PROJECT TITLE Smith's – Yale & Coal TYPE OF SUBMITTAL Drainage Plan

Re: Drainage Plan for Smith's Food and Drug Store at Coal and Yale

Re: Addendum to Drainage Plan for Smith's Food and Drug at Coal and Yale

Ref: Smith's - Coal & Yale Revised 2/4/83
(K15-D17)

BUFFER/RETAINING WALL
1"=10'

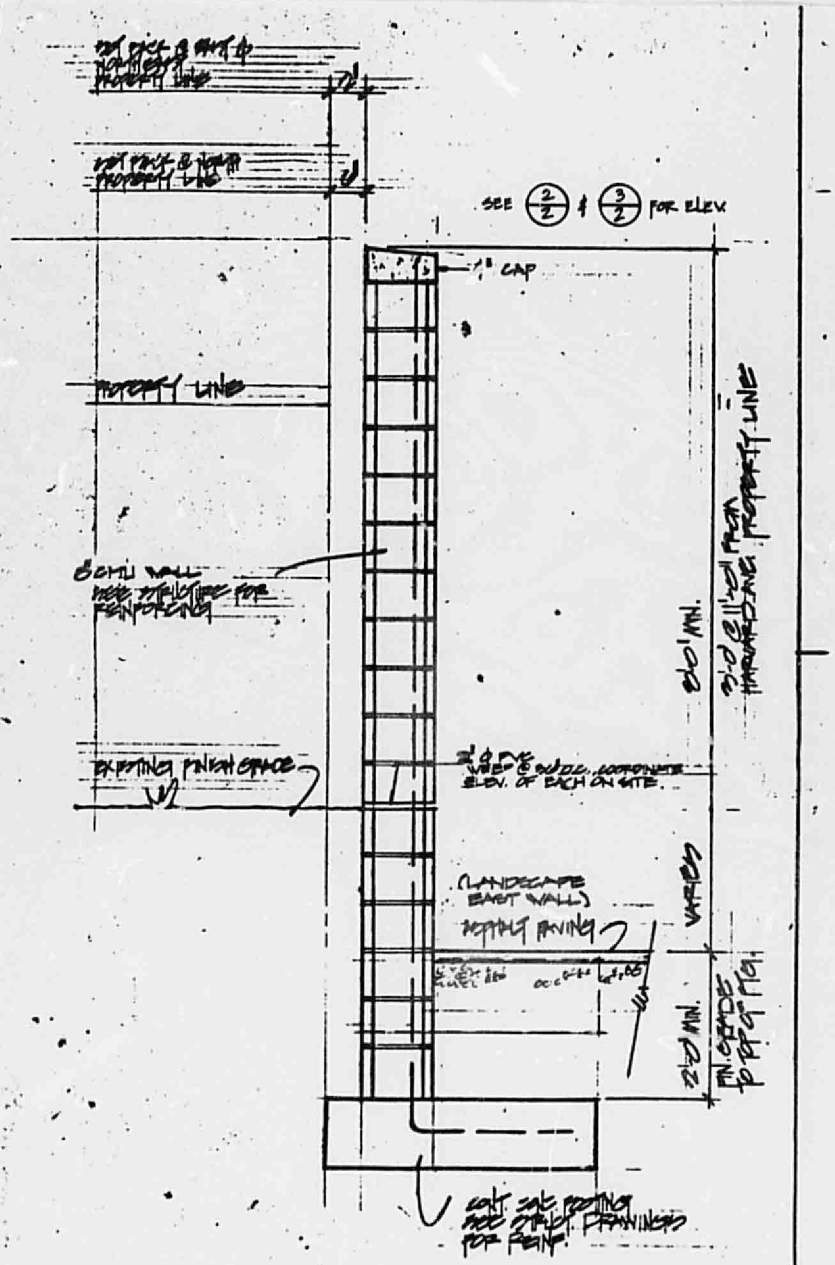
1. Drainage through the retaining walls along the east side of the alley.

SUMP PUMP INSTALLATION DETAIL

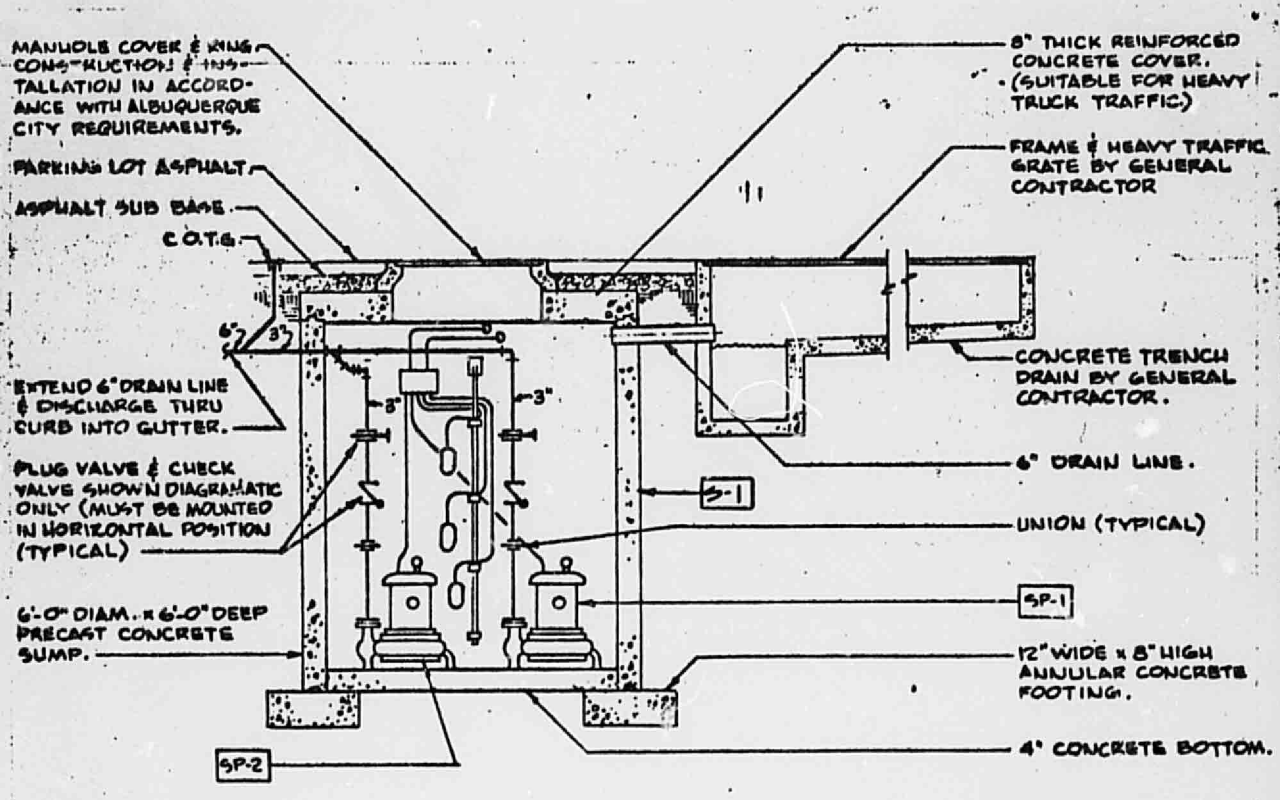
2. Trench drain and sump.

The pump that is being specified on the architectural drawings is a Weil series 2500 submersible pump. The specifications for the pump are:

1. 150 gpm at 29 feet of head.

2. 208 volt, 3 phase, 60 amp, 1750 rpm.

Two of these pumps will be installed with mercury floats, high water alarm, and a control panel for duplex operation. These pumps are within the range of allowable discharge specified in the original drainage plan.
